FORM APPROVED
OMB NO. 1004-0137
Expires: January 31, 2018**SUNDRY NOTICES AND REPORTS ON WELLS**
*Do not use this form for proposals to drill or to re-enter an abandoned well. Use form 3160-3 (APD) for such proposals.*5. Lease Serial No.
NMNM111530

☒ Oil Well ☐ Gas Well ☐ Other8. Well Name and No.
GADWALL 18 FEDERAL COM 3

30-015-39964-00-S1

** BLM REVISED ** BLM REVISED ** BLM REVISED ** BLM REVISED ** BLM REVISED **

Gadwall 18 Federal Com #3H

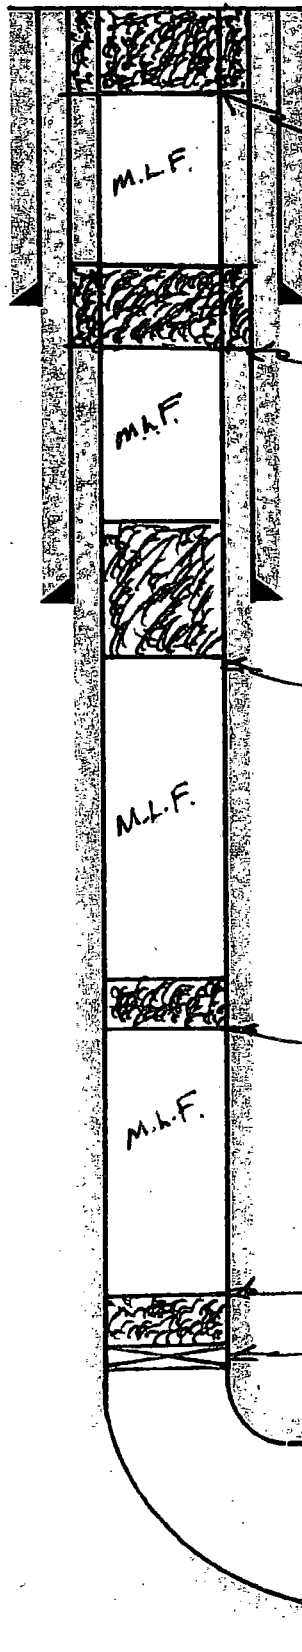
PERF. X SQZ. 55 SXS. @ 521'-421'-TAG

Pump 110 SXS @ 1,956'-1,075'-TAG

Pump 25 SXS @ 5,479'-5,329'

Pump 25 SXS @ 7,300'-7,130'

SET 5 1/2" CIBP @ 7,300'
